PETITION FOR REVIVAL OF AN APPLICATION FOR PATENT  
ABANDONED UNINTENTIONALLY UNDER 37 C.F.R. § 1.137(b)

Title: CALENDER ROLLERS AND METHOD FOR PRODUCING LAMINATED SHEET

**STATEMENT FOR PETITION TO REVIVE UNDER 37 C.F.R. § 1.137(b) AND  
PAYMENT OF FEE UNDER 37 C.F.R. § 1.17(m)**

AMENDMENT UNDER 37 C.F.R. § 1.116  
EXPEDITED PROCEDURE  
GROUP 3725  
PATENT APPLICATION

*FIG. 1A*

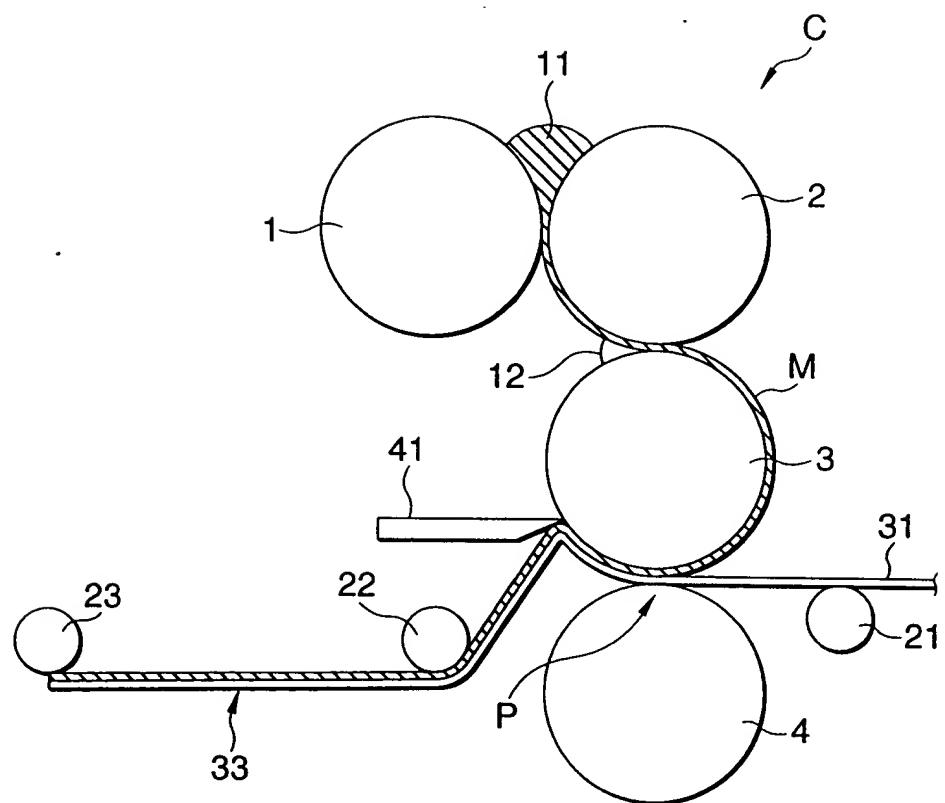
The drawings are objected to under 37 CFR 1.83(a). The drawings must show every feature of the invention specified in the claims. Therefore, means for heating (claim 2), means for vibrating (claim 3), a band heater (claim 11), and an air cylinder (claim 12) must be shown or the feature(s) canceled from the claim(s). No new matter should be entered.

Applicant does not clearly define the term “behind” the nip portion. If the release member is only a millimeter away from the center of the nip portion, it is considered that the release member is behind the nip portion. Figure 1 clearly shows the doctor knife (14) in contact with a holding roll (4) near a nip portion between roll (4) and roll (12). Therefore, it is inherent that the release member is arranged in contact with the holding roll (4) “behind” the nip portion, and it is inherent that the plastic material sheet layer is curl/peel off the roll when being release by the release member.

Regarding the rejection to Claim 5 (the layer is curled/peeled off the roll), Applicants traverse the Examiner's rejection of Claim 5 by pointing to Fig. 1 which clearly shows that a plastic material sheet layer of said laminated sheet is released from said holding roller by curling it with said release member. Furthermore, Applicants submit that the curling process is deliberately created by the Applicants to support certain unexpected benefits in production such as a smoother tackiness surface without generating the projections and depressions on the surface of the pressure-sensitive adhesive.

Submitted herewith please find 3 sheets of proposed drawing corrections (Figs. 1A, 1B and 1C) indicated in red ink with the changes described below. The Examiner is respectfully requested to acknowledge receipt of the drawing corrections and to approve the changes.

Fig. 1A is a view illustrating calendar rollers provided with a doctor knife disposed behind a nip portion of a center roller (holding roller) for holding a plastic material sheet. Fig. 1B illustrates a means for heating a release member with a band heater, indicated by reference number 42, attached to a doctor knife, indicated by reference number 41. Fig. 1C illustrates a means for vibrating a release member with an air cylinder, indicated by reference number 43, attached to a doctor knife, indicated by reference number 41.
